**Report: TAB Report**  
**Function: Test, Adjust, & Balance**  
**Date: 06/27/2024**

**06-24-24 WAWA #5413 SARASOTA, FL**

Project: 06-24-24 WAWA #5413 SARASOTA, FL

IMG\_0549  
06/26/2024

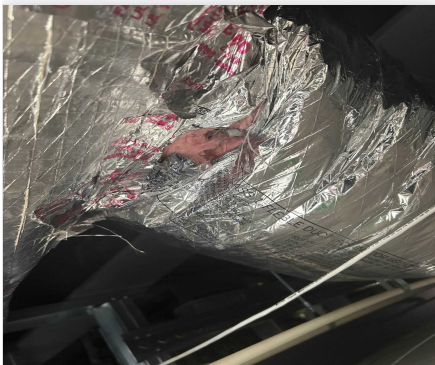
**Issue Name :** Diffuser 2-1 - damper missing wing nut  
**Description :** Diffuser 2-1 currently has an airflow of 677 CFM (135% of design) and cannot be lowered because the damper will not hold the required position; it is missing a wing nut opposite the handle. Recommend repairing damper to allow for airflow adjustment.

- **06/30/2024 National TAB - Mark Johnson**
  - Mechanical clarified that damper design does not require second wing nut, and tightened handle to allow for adjustment. Could not re-adjust on site under time constraint.

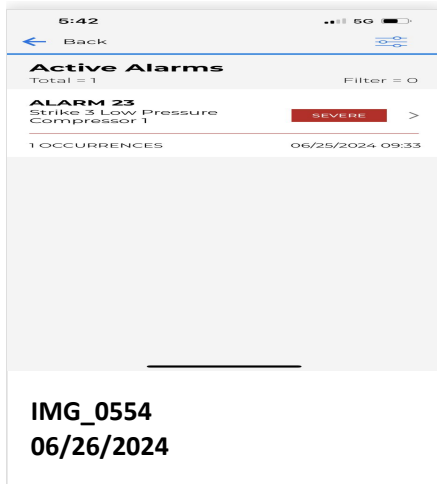
**Issue Name :** EF-2 low flow  
**Description :** EF-2 is experiencing low exhaust flow (22 CFM, 37% of design) after installation of speed controller. Additionally, the fan is starting and stopping at frequent intervals. Fan is set to max speed. Recommend checking speed controller and wiring for possible faults.
